**WOKINGHAM
BOROUGH COUNCIL**

Householder Consultation

Application Number: 242284

Proposal: Householder application for the proposed entrance gates and pillars.

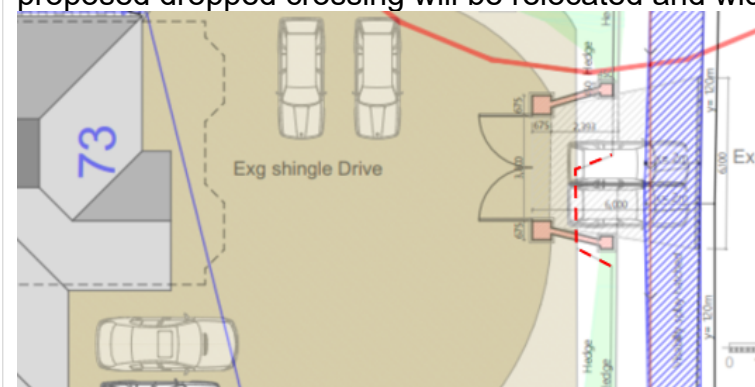
While the proposal indicates that the gates will utilise the existing crossover, it does not reflect the reality. The proposed plan has been overlaid with the approved site plan of 221580 (approved access marked in red dotted line), indicating that the proposed dropped crossing will be relocated and widened.

The plan shows that the dropped crossing width of 6.1m is wider than the recommended maximum width of 3.6m by the Traffic Management team, which exceeds the guidance and have to be achieved by encroaching the public footway. The applicant is recommended to revise the access width and provide the new entrance gates by utilising the existing dropped crossing.

Shall the applicant intend to proceed with the extended dropped kerb and hard surfacing, separate consent will be required from the Traffic Management team for the proposed width and location of the new dropped crossing after the planning application is approved.
